Job Reference: 0002279-T
Council Reference: A006504068

REQUEST FOR MINOR CHANGE TO DEVELOPMENT APPROVAL – A006504068

Development Type:	Multiple Dwelling
Site Address:	128-130 Swann Road TARINGA QLD 4068
Real Property Description:	Lot 117 RP23368 Lot 118 RP71354
Council Reference:	A006504068
Approval Type:	Material Change of Use – Multiple Dwelling (9 units)
Planning Scheme Benchmarks:	Medium Density Residential Zone Taringa Neighbourhood Plan (no precinct) Multiple Dwelling Code Filling and Excavation Code Infrastructure Design Code Landscape Work Code Outdoor Lighting Code Stormwater Code Transport, Access Parking and Servicing Code Airport Environs Overlay Bicycle Network Overlay Community Purposes Network Overlay Critical Infrastructure and Movement Network Overlay Road Hierarchy Overlay Streetscape Hierarchy Overlay

Figure 1: Section comparison illustrating the approved undercroft area and the extent of the proposed suspended undercroft parking level. (Source: Contreras Earl Architecture)

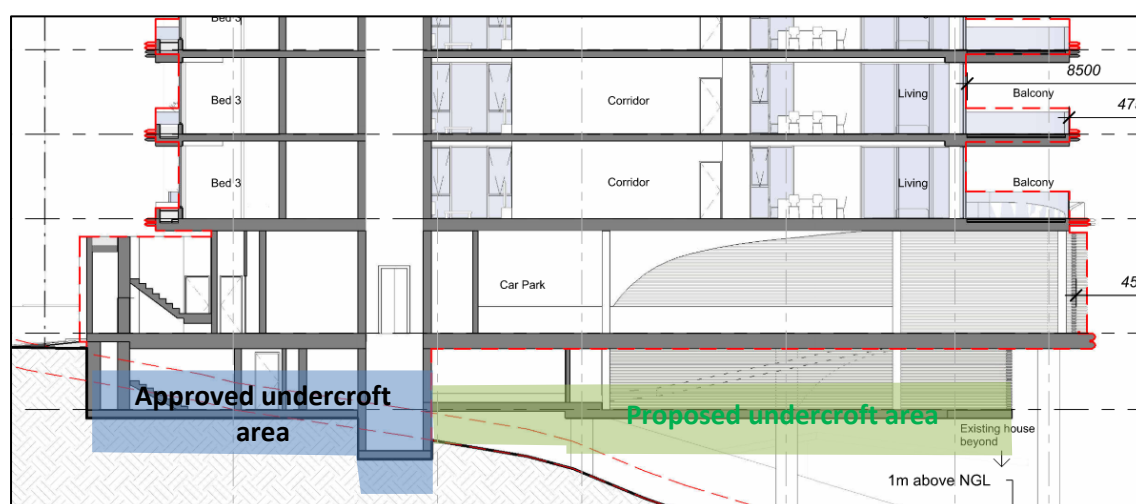
A suspended car park is proposed within the existing approved undercroft of the building and is intended to provide additional parking and private storage for the eleven (11) dwellings. As illustrated in Figure 1, the majority of the proposed area is accommodated within the existing undercroft area approved by Council, with the amendment comprising a partial infill of this area.

As shown in Figure 1, the proposed works occupy only a portion of the approved undercroft and do not extend across its full length or height. At approximately 2.8 metres in height, the suspended parking level remains subordinate to the approved building and does not materially increase the bulk, scale, visual prominence or overshadowing of the development. Any potential impacts associated with vehicle movements, light or noise pollution will be appropriately mitigated through architectural screening and the existing separation distances to adjoining properties. Accordingly, the proposed change does not result in significant additional amenity impacts when compared to the approved development.

Figure 3: Level 04 Floor Plan. (Source: Contreras Earl Architecture)

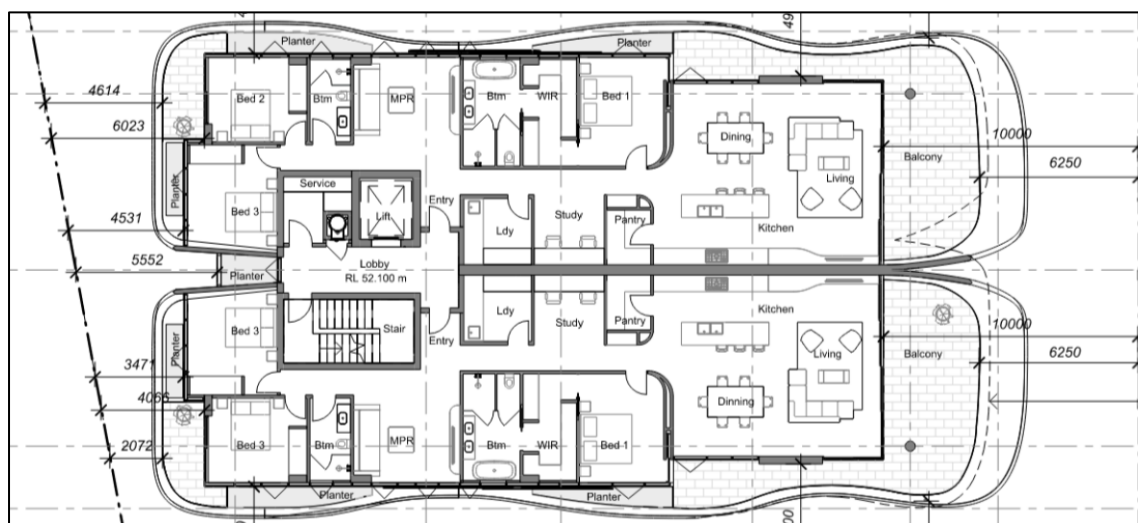
The proposal includes the addition of a new 'Level 04 residential floor' between the approved Level 03 and Level 05 penthouse level, increasing the approved development yield from nine (9) dwellings to eleven (11) dwellings.

The increase in dwelling yield is facilitated through the introduction of the additional residential level, which accommodates two (2) further dwellings.

Refer to Figure 2 below for a visual comparison of the approved and proposed development. Figure 3 illustrates the proposed new Level 04 floor plan.

Figure 4: Proposed western section showing outline of approved DA. (Source: Contreras Earl Architecture)

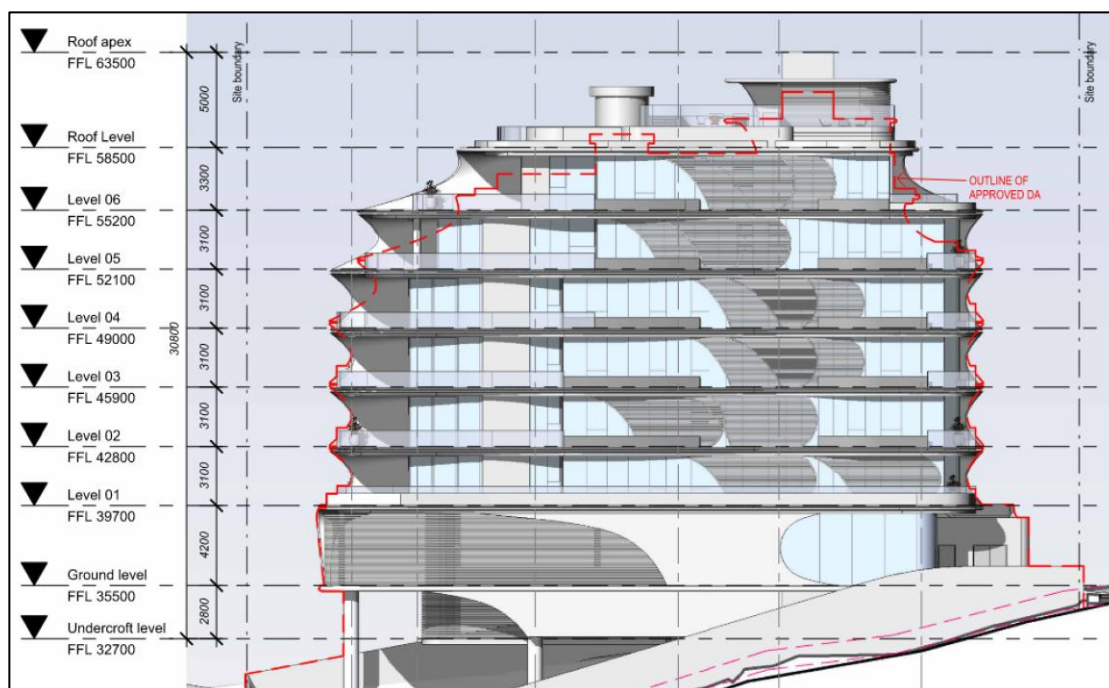
To accommodate the additional Level 04 residential floor, floor-to-floor heights throughout the building have been reduced, enabling the revised development to incorporate an additional storey while limiting the overall increase in building height to 2.1 metres. As demonstrated in Table 2 below, the additional storey has largely been absorbed through modest reductions in floor-to-floor heights across the building, rather than resulting in a proportionate increase in overall height.

Figure 4 below illustrates the proposed western section, with the red dashed outline identifying the approved development envelope and highlighting the limited extent of the height increase.

Figure 5: Comparison of eastern building envelopes. (Source: Contreras Earl Architecture)

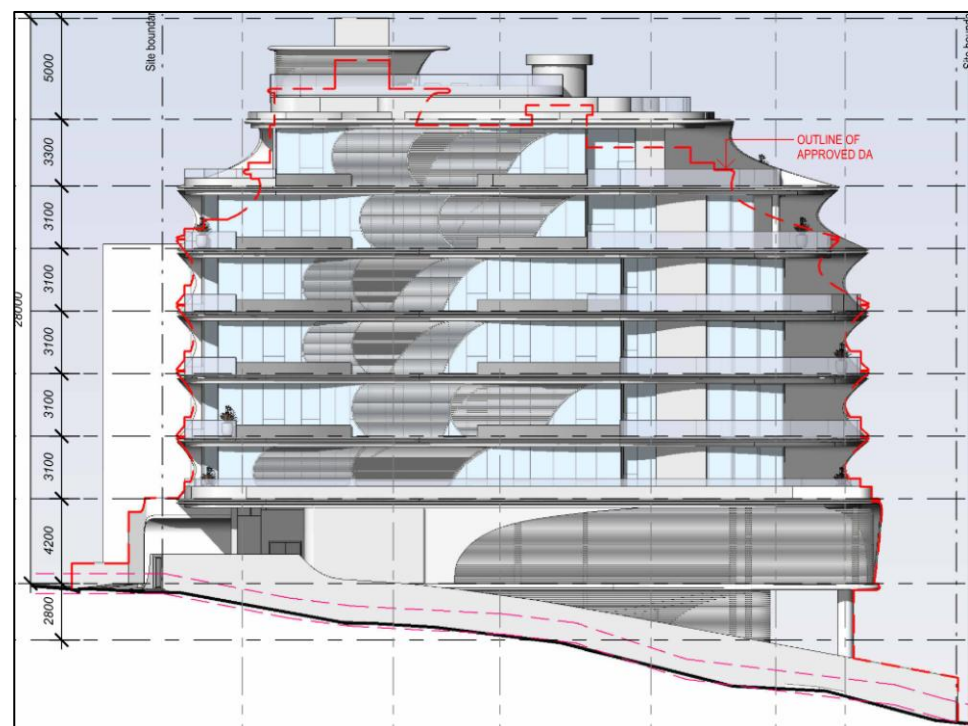
The majority of the revised development, including the additional residential level, remains within the approved building envelope. The limited elements extending beyond the approved envelope comprise:

Level 04:

- External façade elements associated with the northern balconies.

Level 05:

- External façade elements associated with the northern and southern balconies.

Level 06 (penthouse):

- External façade elements and minor portions of the northern and southern balconies.

Rooftop Terrace:

- Reconfigured rooftop terrace areas extending beyond the approved envelope with an overall building height increase of 2.1 metres.

As illustrated in Figure 5, the areas extending beyond the approved envelope are largely limited to façade articulation, balcony projections and rooftop terrace elements. These encroachments do not result in a substantial increase

Figure 7: Shadow diagrams of proposed development. (Source: Contreras Earl Architecture)

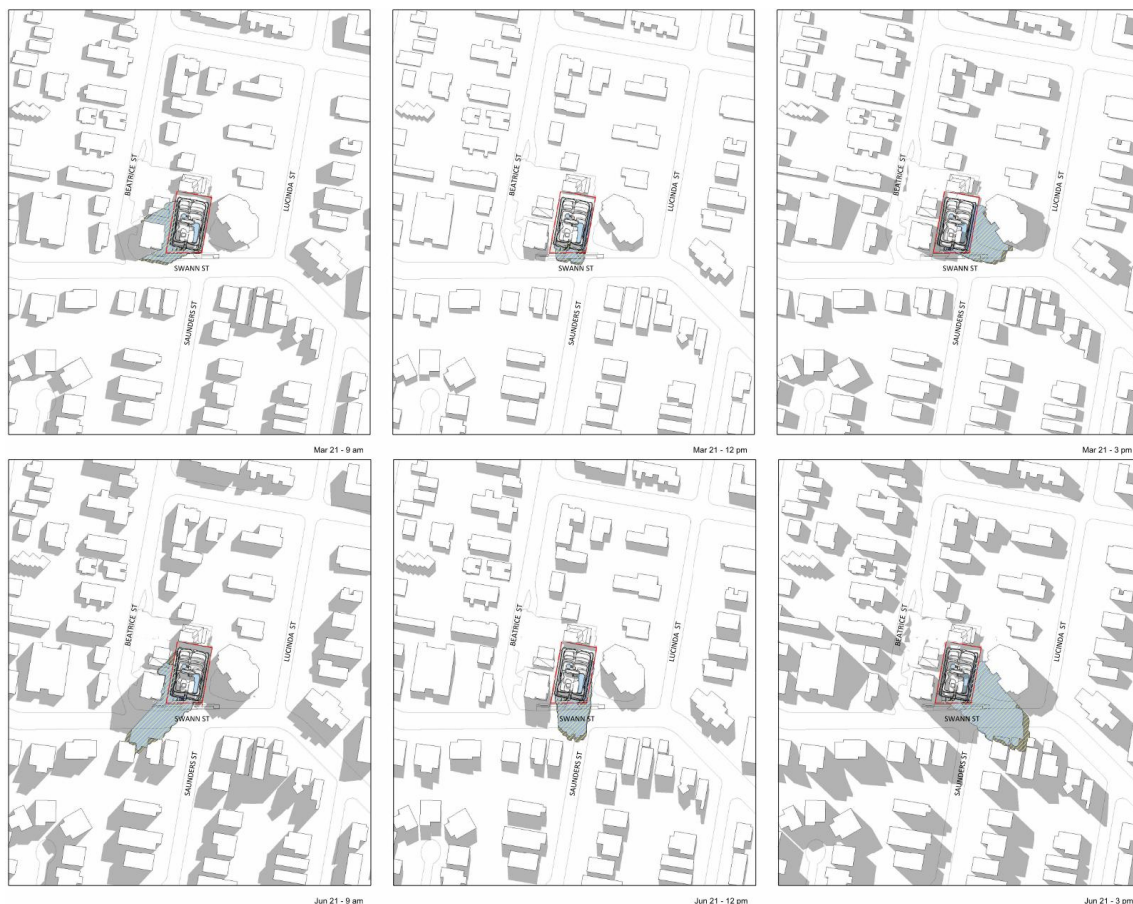
The matters raised in the original submissions relating to privacy, visual bulk, scale and overshadowing have also been reassessed as part of this minor change application. Comparative plans, elevations and shadow diagrams demonstrate that the proposed amendments do not give rise to materially different impacts from those already considered and accepted by Council under the original approval. In particular, the shadow diagrams (refer Figure 7) confirm that the shadow extent generated by the amended development is substantially consistent with that of the approved development across the March, June and December assessment periods.

While the proposal incorporates an additional residential level, the increase in overall building height is limited to approximately 2.1 metres and has largely been absorbed within the approved building envelope through reduced floor-to-floor heights. Consequently, the additional shadow cast by the amended development is negligible and generally confined within the shadow envelope already established by the approved scheme. The diagrams illustrate that adjoining residential properties, streets and surrounding public spaces experience shadowing outcomes that are materially the same as those approved by Council, with no significant increase in overshadowing impacts.
